The comments in green were made by Kendra Hanagami, and can be contacted at khanagam@auroragov.org

TARAHUMARA SUBDIVISION FILING NO. 1

COVER SHEET
2260 ANDES WAY

UTILITY PLAN	CAD NO	JOB NO
2260 ANDES WAY	954-1	954-1
AURORA, CO 80011

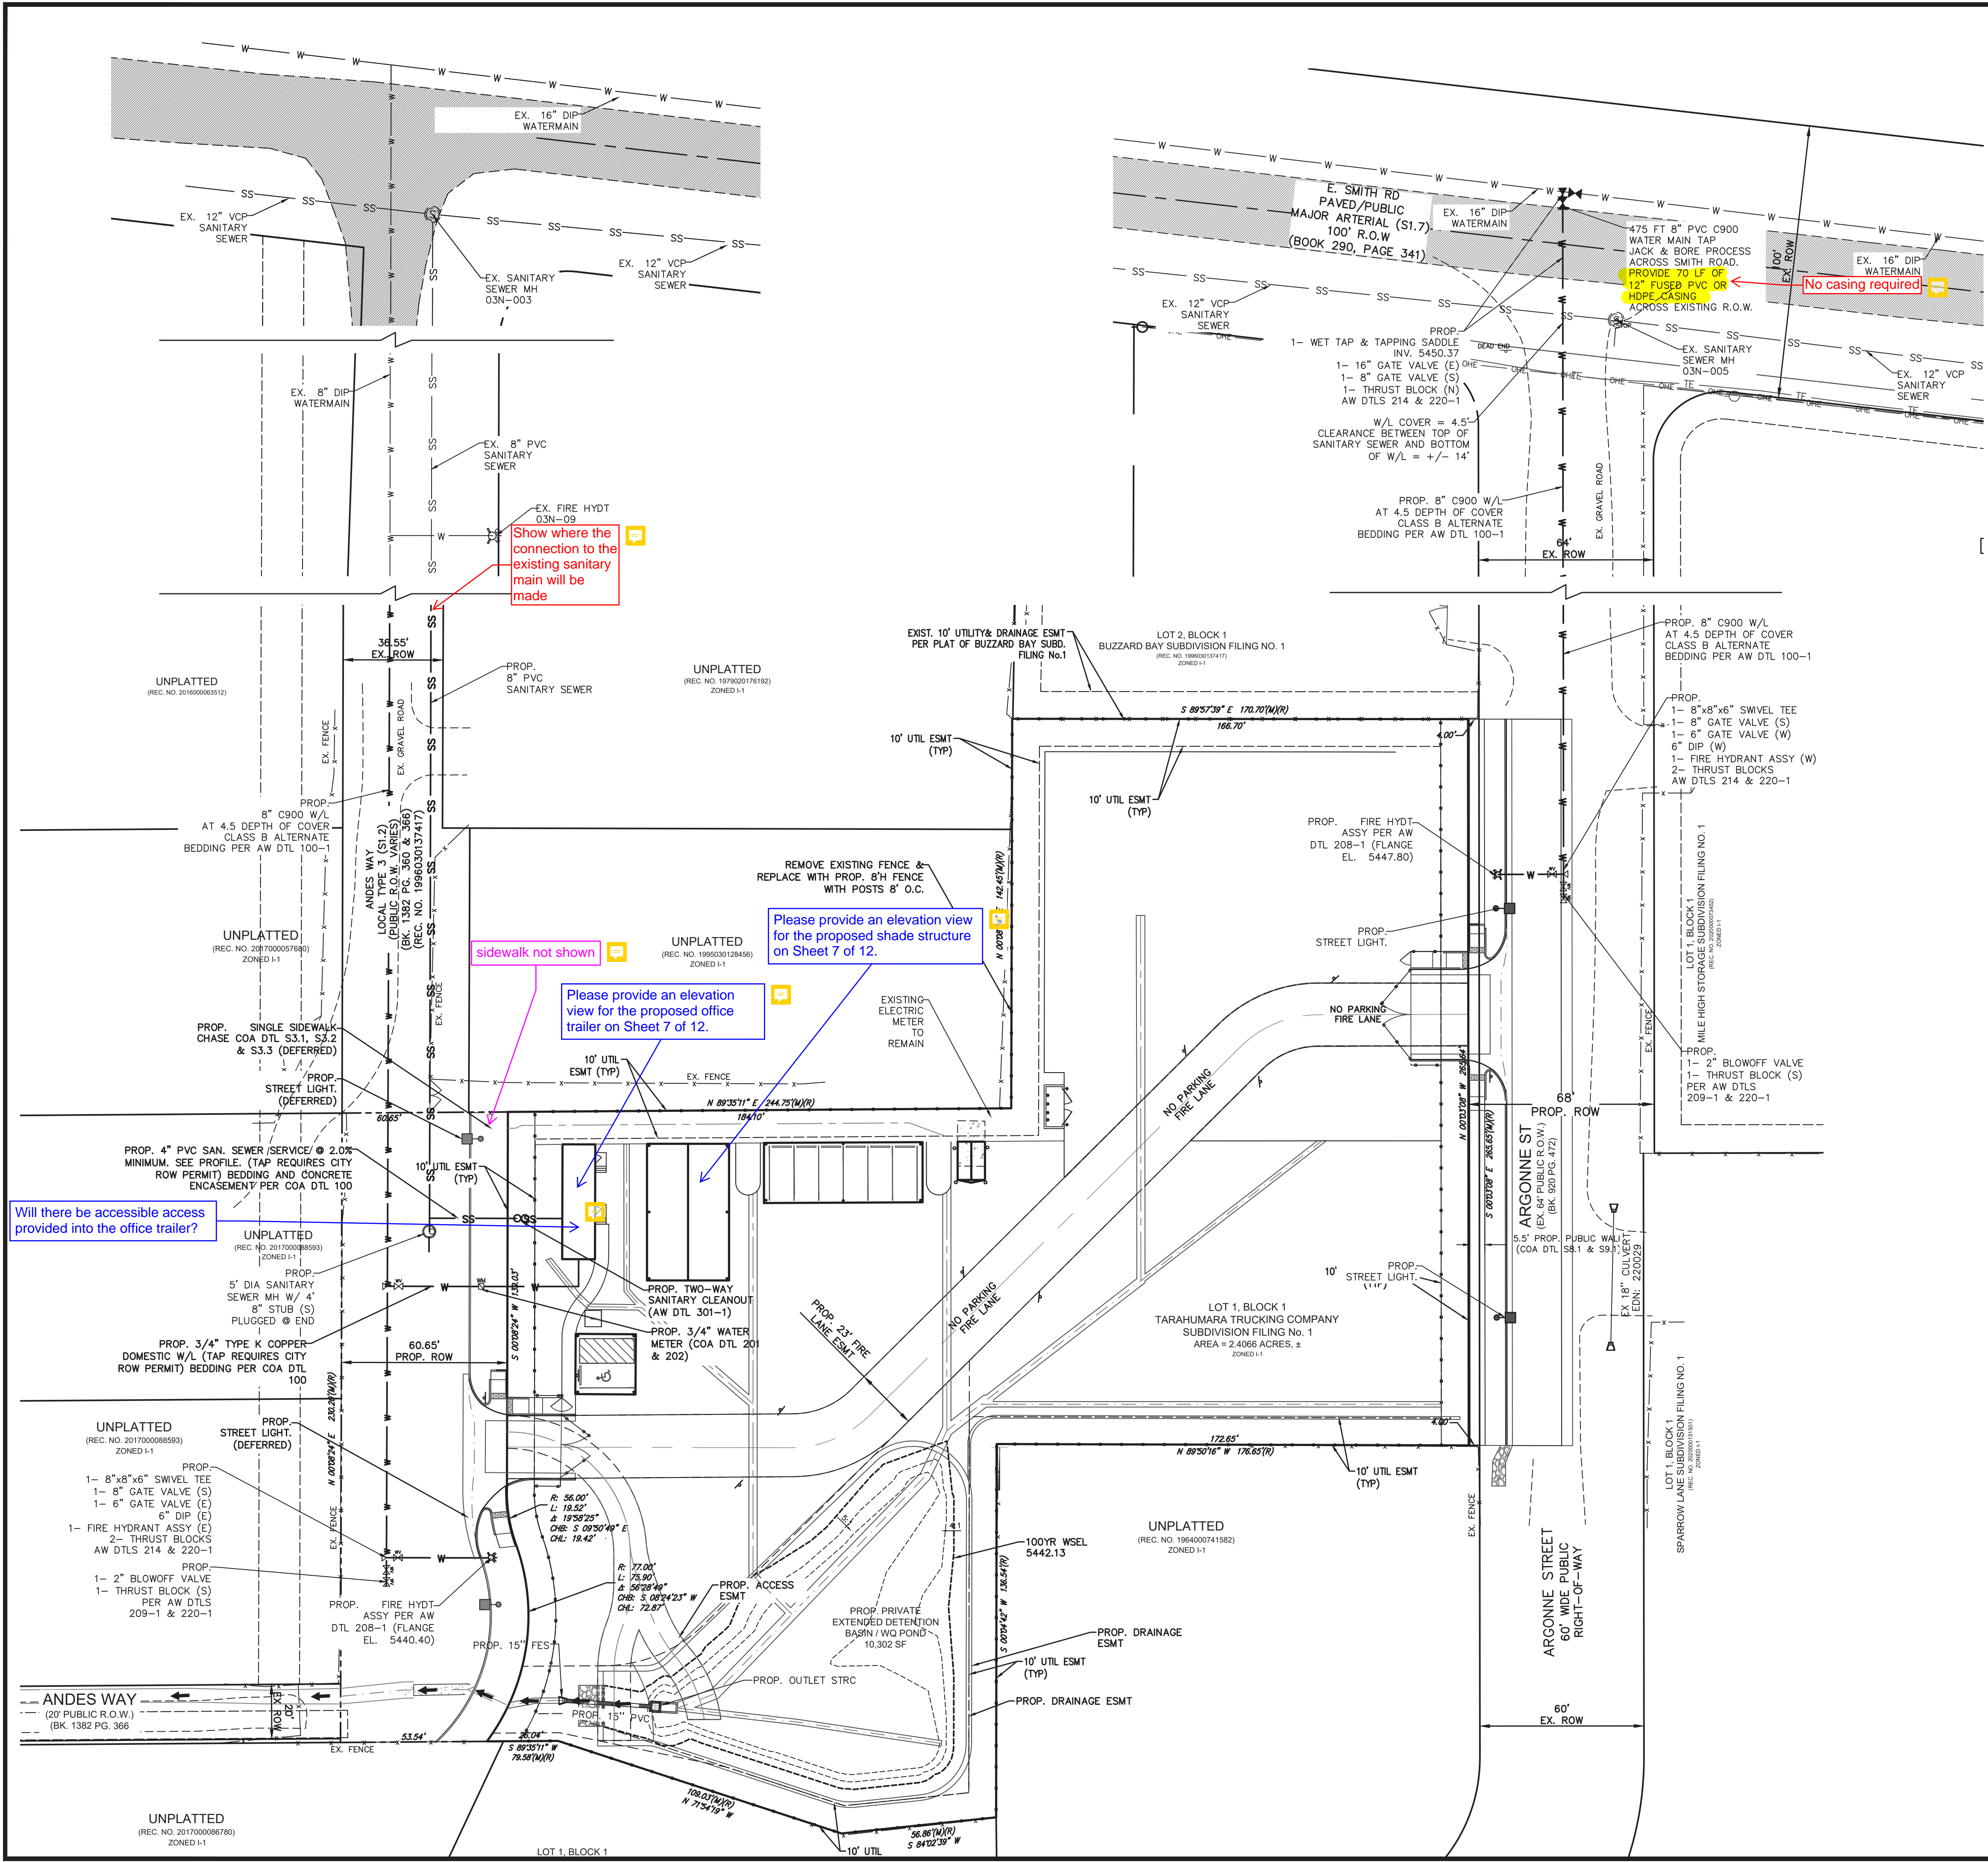
Show these notes:
1) Water service lines are public up through the meter and are private downstream of the meter.
2) All sanitary service connections are private.

INTERIM GRADING PLAN
2260 ANDERSON WAY
AURORA, CO 80011

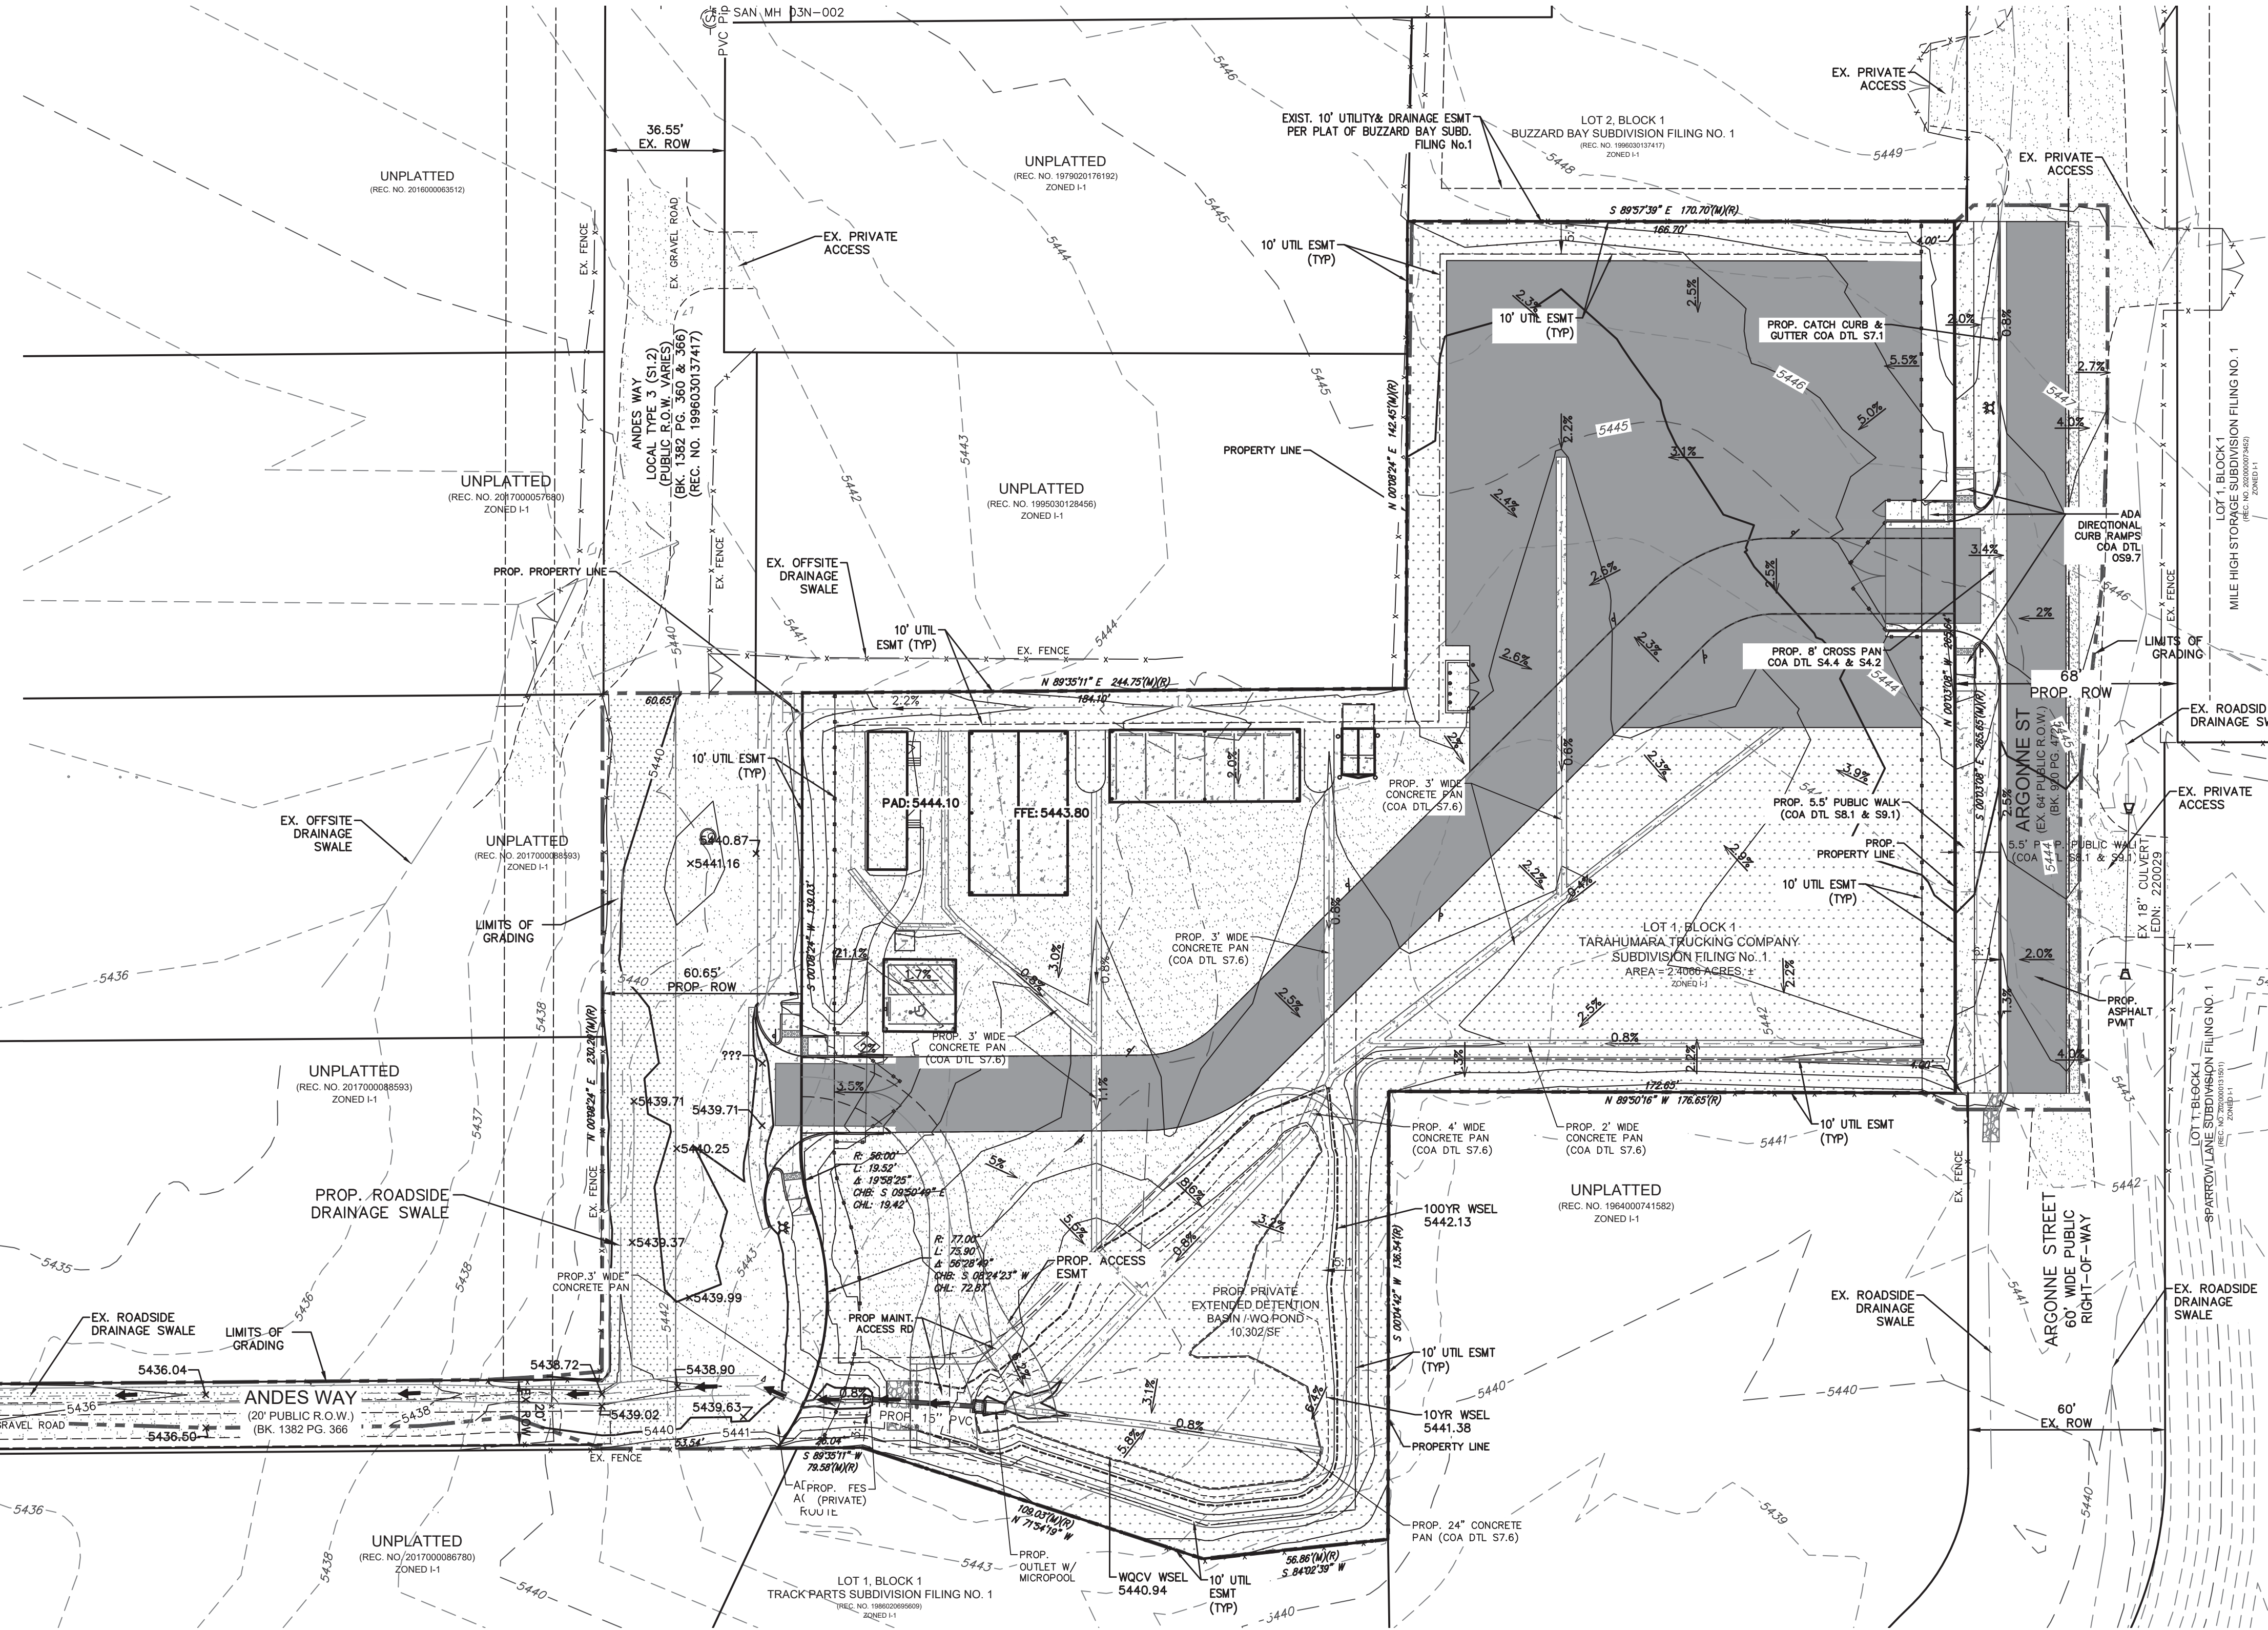
- Please add the following notes:
- Minimum slope on unpaved areas is 2%, minimum slope on asphalt is 1%, and minimum slope on concrete is 0.5%.
 - The maximum slope within ROW is 4:1, the maximum slope for property outside of the ROW is 3:1.

- The slope away from the building shall have a minimum grade of five (5) percent for the first ten feet or to the property line, whichever occurs first, then a minimum of two (2) percent until the slope reaches the swale around the building. If physical obstructions or lot lines prohibit the ten feet of horizontal distance, a five (5) percent slope shall be provided to an approved alternative method of diverting storm runoff away from the foundation. Impervious surfaces within ten feet of the building foundation shall be sloped a minimum of two (2) percent away from the building.

- The maximum permissible longitudinal grade for fire lanes is 10%. The maximum transverse grade for a fire lane is four percent with a resultant maximum slope of ten percent.

- The resultant grade in any direction within accessible parking areas shall not exceed two percent.
 - The maximum cross slope in an accessible path shall not exceed two percent. The maximum longitudinal slope along an accessible path shall not exceed five percent.

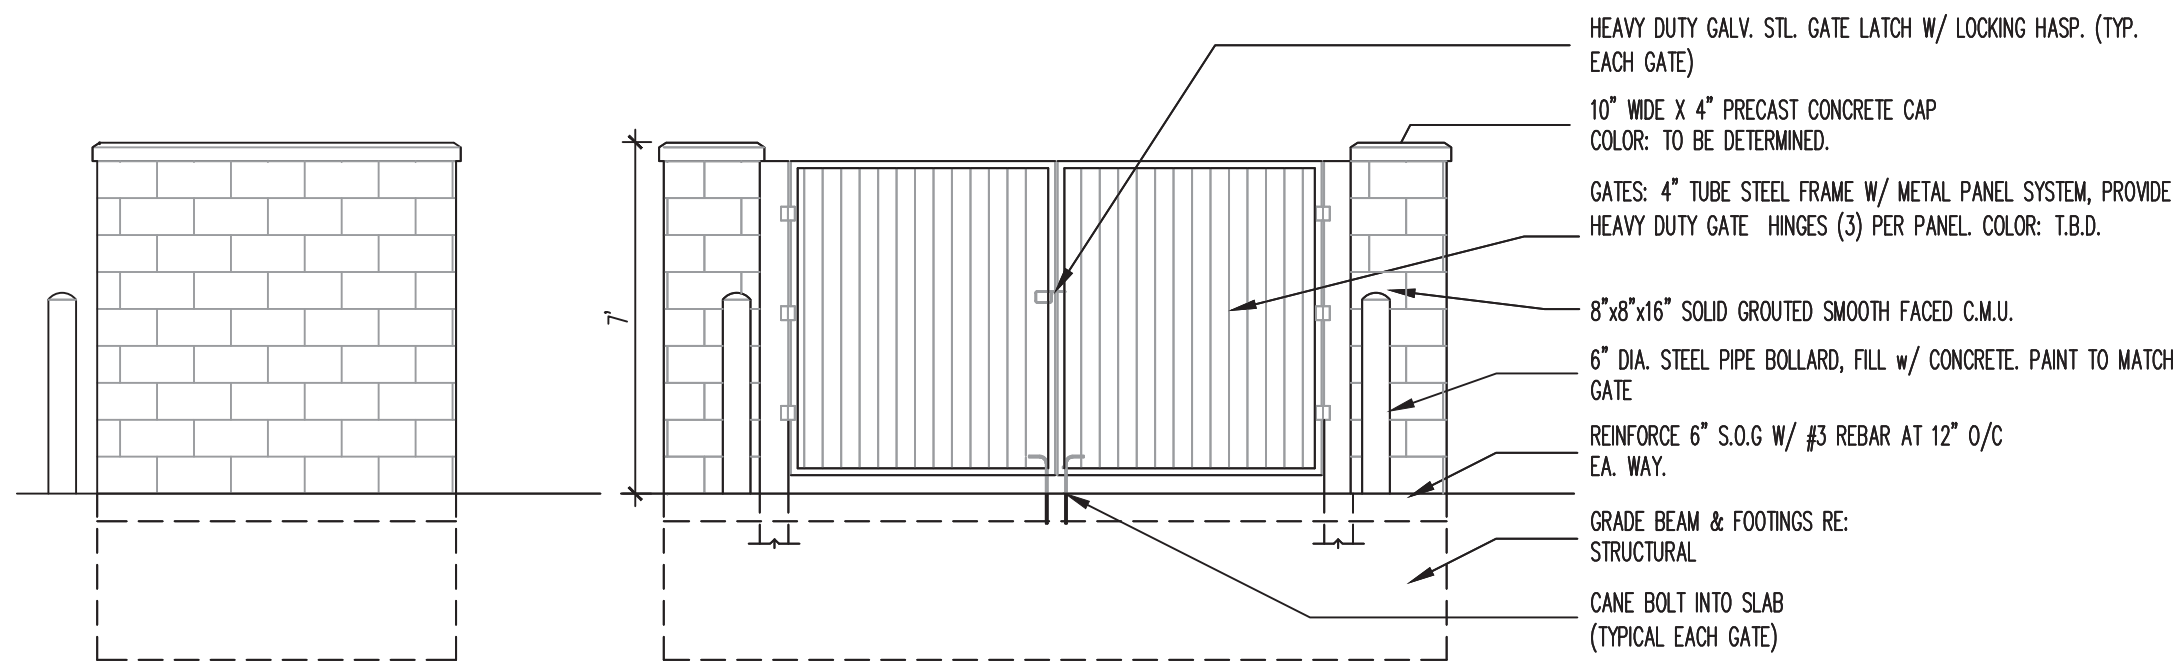
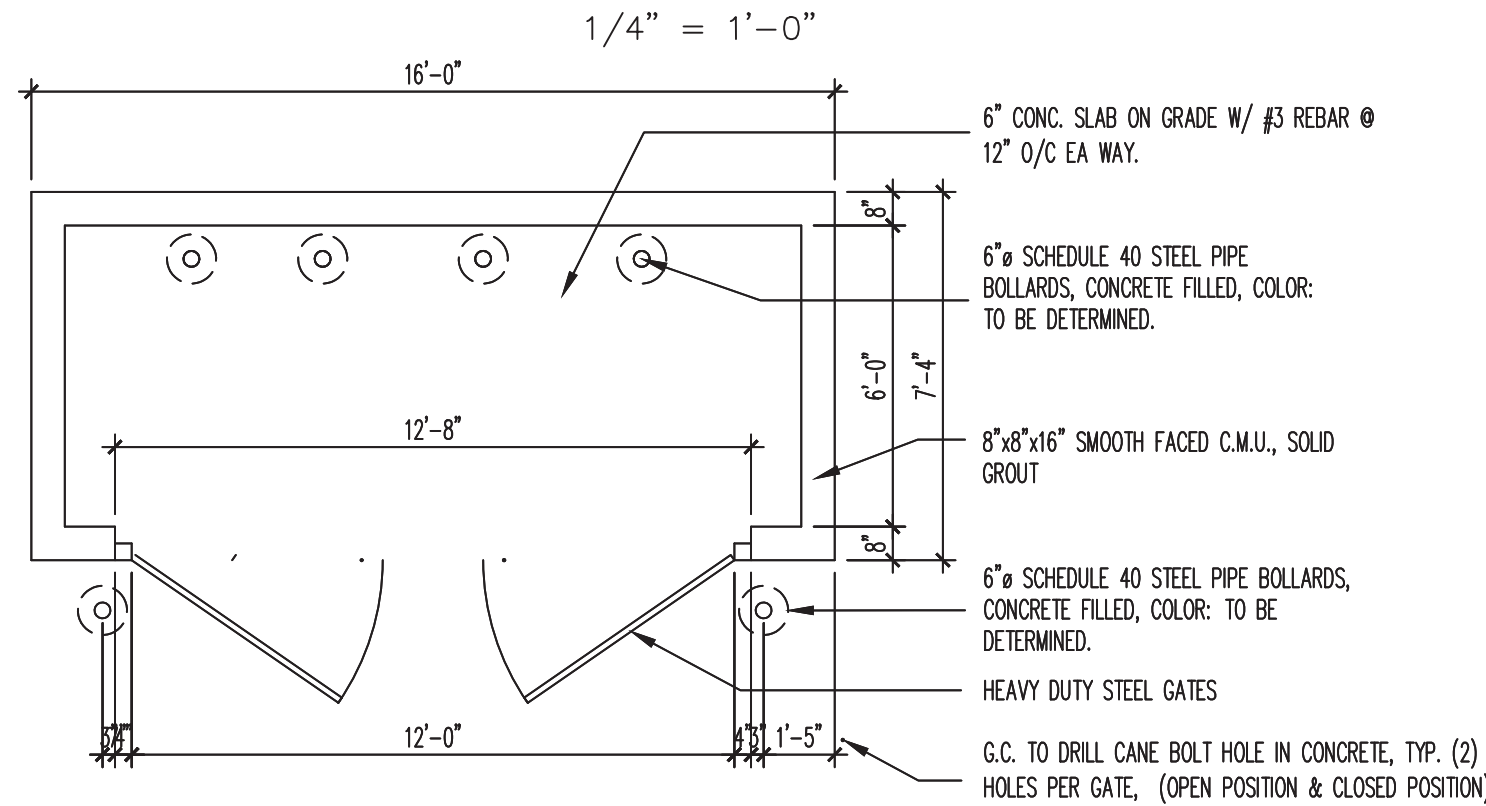
Please provide an elevation view for the proposed shade structure.

Please provide an elevation view for the proposed office trailer.
